Review of Proposed Modifications to Stoughton Dam
Town of Pleasant Springs Board
July 12, 2022

Emmons and Olivier Resources, Inc.
Steve Gaffield, PE, PhD

Low flow (150 cfs)

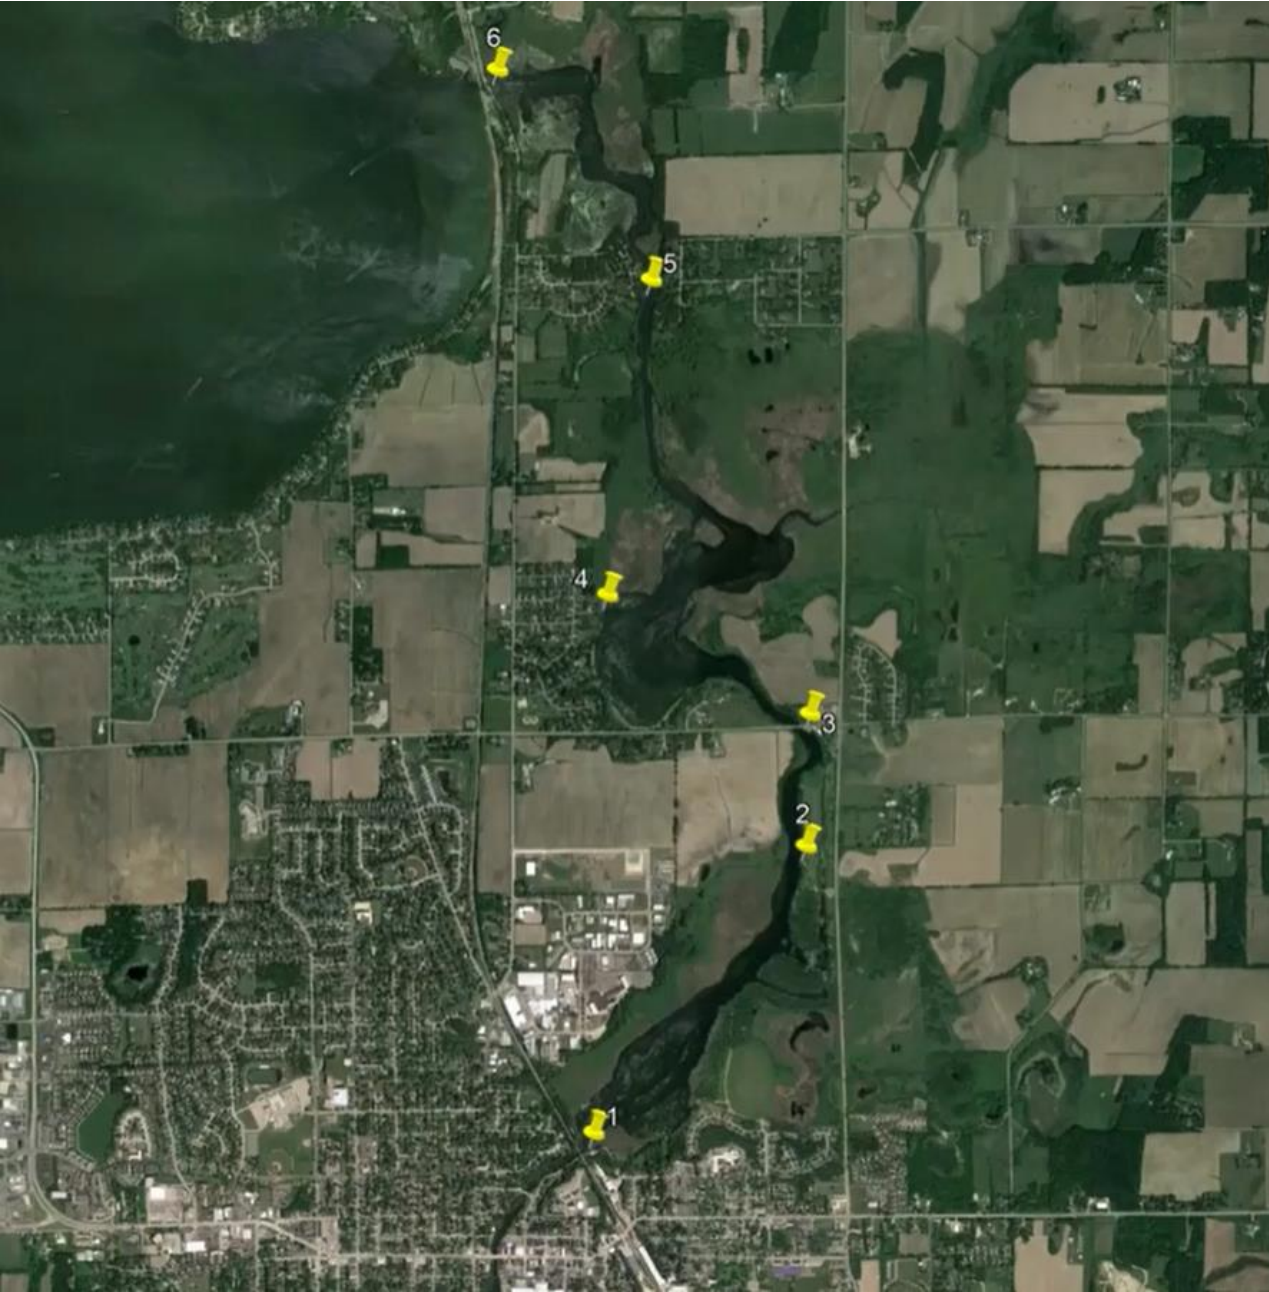
- **0.6 – 1.6 ft water level drop**
 - Lower drop is for summer vegetation
 - Higher drop is without thick veg. growth

- **0.3 – 0.8 ft water level drop**

- **0.1 – 0.3 ft water level drop**

Predicted water level drop is large compared to existing water depth upstream of CTH B.

Changes in River Channel

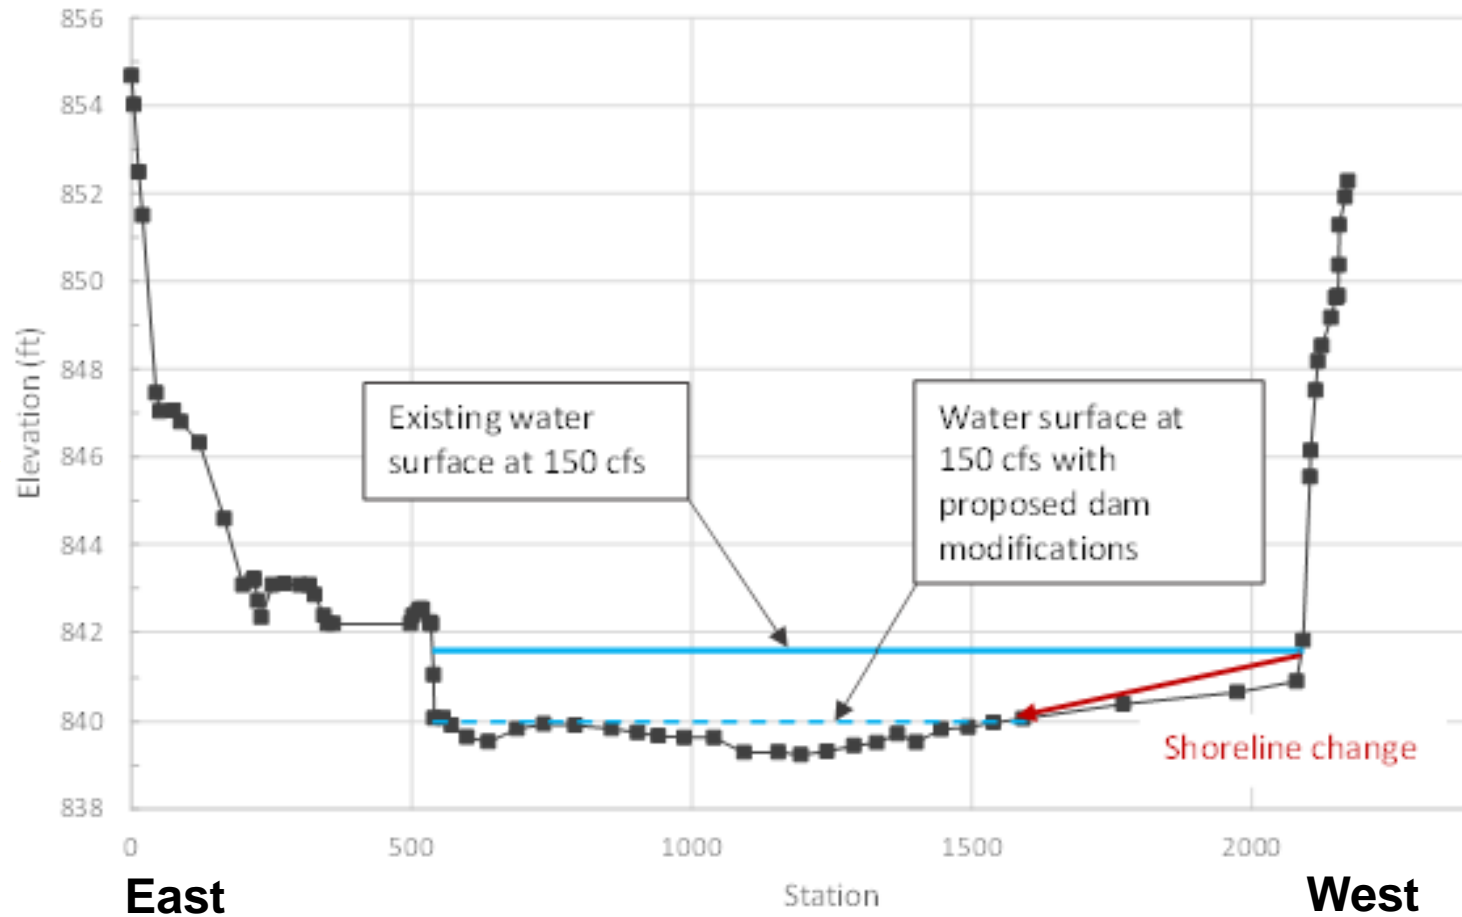
Shoreline change depends on riverbed elevation.

No new riverbed data collected.

Cannot map shoreline change without additional data.

Only available riverbed elevation data is from Flood Insurance Study.

Hydraulic profile at 150 cfs

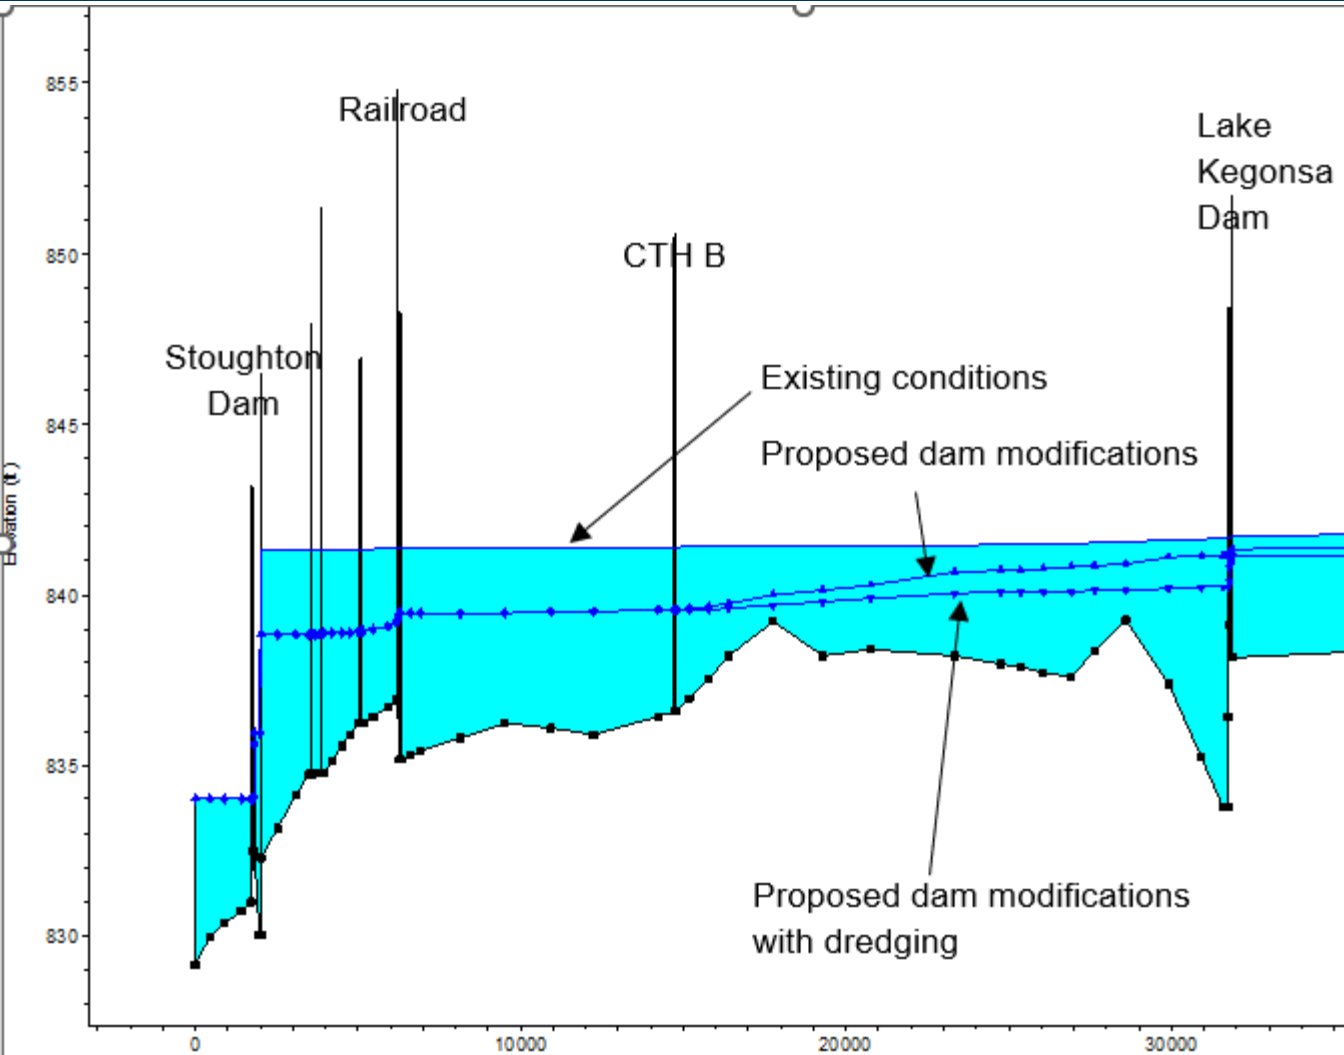
- **Dredging + dam modifications will lower water levels further than dam modifications alone.**
- **Approximately an additional 0.3 ft in widening upstream of CTH B at 150 cfs.**

Dredging effect is temporary; sedimentation will continue.

Sedimentation affects local water depth as well as floodwater conveyance.
